VILLA INTERNATIONAL				
ABTS HINGE LINK, RECALL REPAIR				
JGM 4.21.14	SIZE	FORM NO.	DWG NO.	REV
	SCALE		02

REFERENCE NHSTA RECALL # 14E009

LH SIDE VIEW

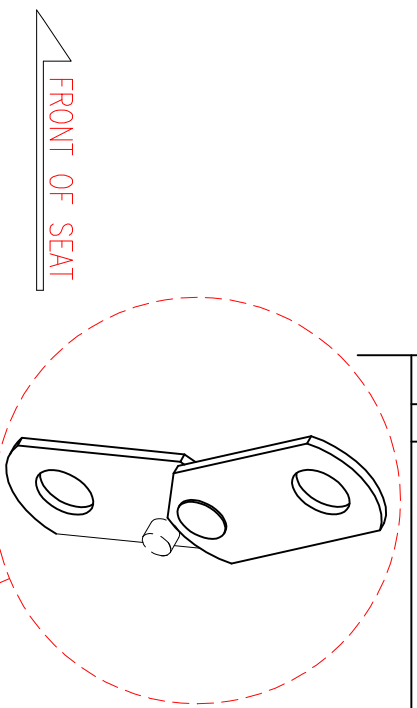
ABTS HINGE LINK
SHOWN INSTALLED
INCORRECTLY
WHEN THE LOWER
LINK IS INBOARD
TOWARD THE SEAT
FRAME.

THIS REPAIR IS INTENDED ONLY FOR THOSE ABTS HINGES INSTALLED INCORRECTLY AS SHOWN IN THE LH SIDE VIEW.

REMOVE TWIST IN SEAT BELT BEFORE INSTALLING SHEATH AND FASTENING END.
